## Technical change to IE-SW-VL05M-series (5-Port Fast Ethernet managed Switches)

- PCN-number: PCN-PN48-20190207-00-A
- date of publishing: 7<sup>th</sup> February 2019
- revision number: A

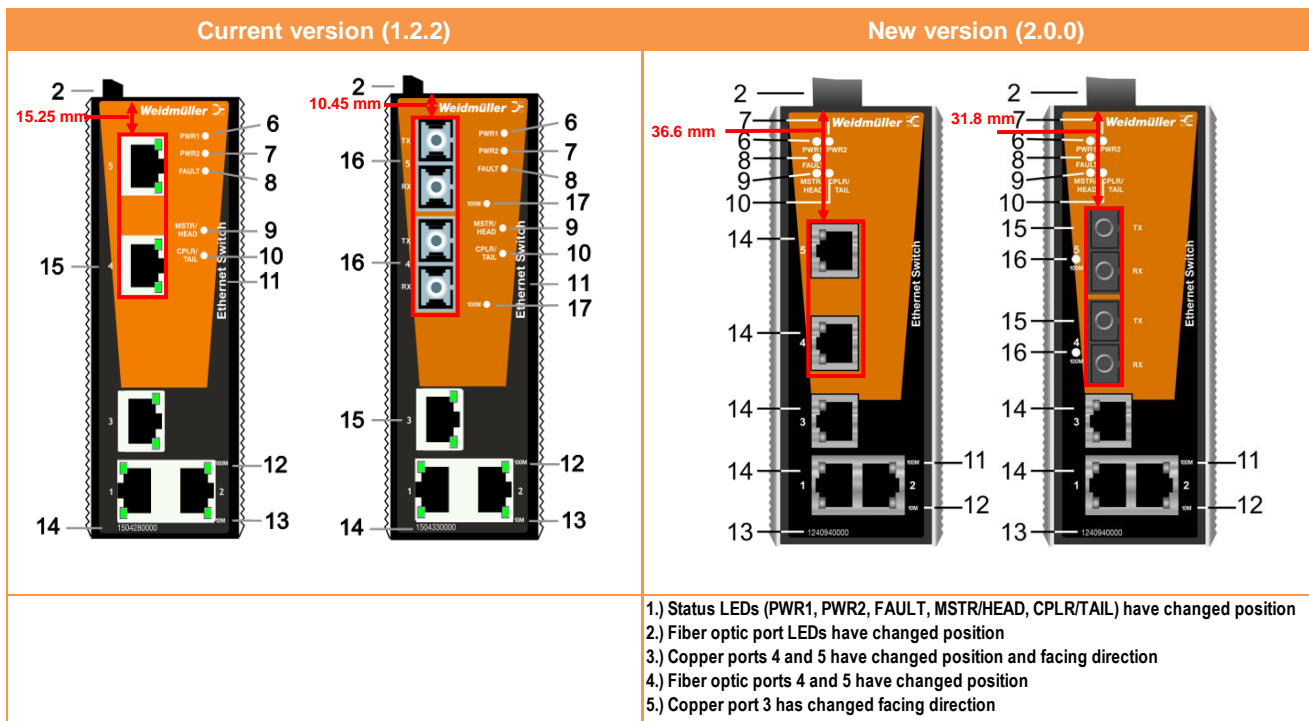
4.) Position of LEDs, ports (fiber optic/copper) changed with new product version. Valid for products in table below. Refer to below figure for more details.
